PACIFIC BROOK CHRISTIAN SCHOOL C/- NBRS ARCHITECTURE

ACCESS ASSESSMENT REPORT

*Pacific Brook Christian School – 72-74 Maitland St,
Muswellbrook NSW*

Revision: r9

Figure 1 – Stage 1 Site Plan

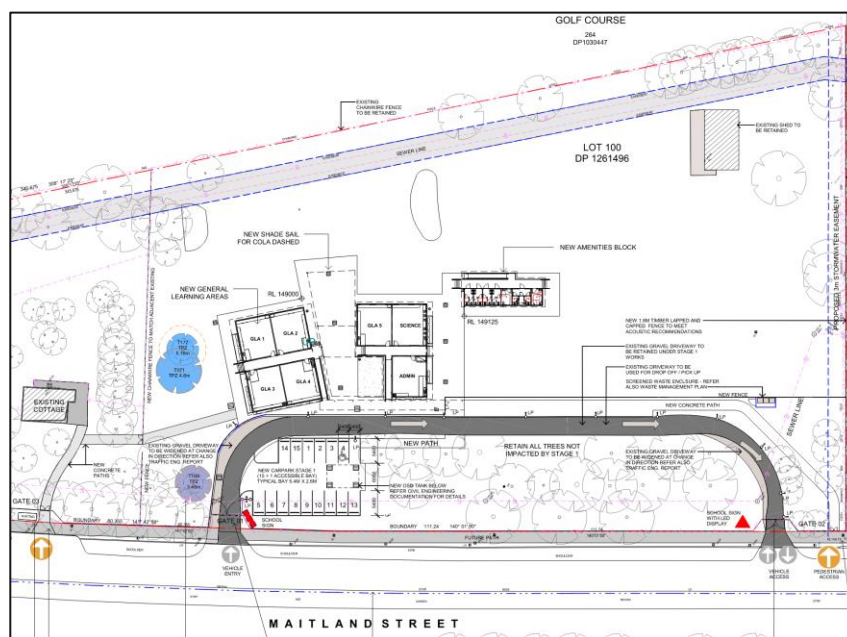
- > Further design documentation is required for assessment of the external paths of travel providing access from the allotment boundary, accessible parking bay and pedestrian link between buildings to the new works to ensure accessibility requirements of AS1428.1-2009 i.e. gradient, crossfall and landings are capable of being achieved.

Staff Amenities

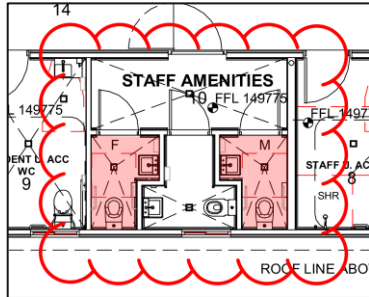
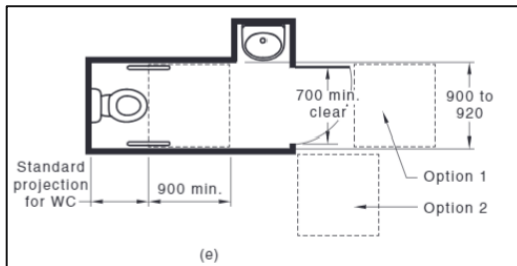
Further design development is required as per the following:

- > At both male and female staff ambulant compartments, provide solid/continuous walls on both sides of the compartment for the full 900mm forward of the WC pan and clear of the washbasin as per AS1428.1-2009. While not referenced in BCA2022, the updated standard being AS1428.1-2021 has further clarified this requirement (see Figure 52(B) of AS1428.1-2021 below). Currently the washbasin still located adjacent to the 900x900mm circulation zone with no solid wall on each side of the 900 x 900mm circulation zone.
- > The staff unisex accessible facility is required to provide 2350mm compartment width to ensure the proposed shower seat does not encroach into the WC pan circulation space when folded down as per AS1428.1-2009 – current documentation demonstrates that this is likely to occur given the 2260mm

compartment width. Consider reducing the width of the student unisex accessible WC (while maintaining WC pan circulation space) to accommodate for this.
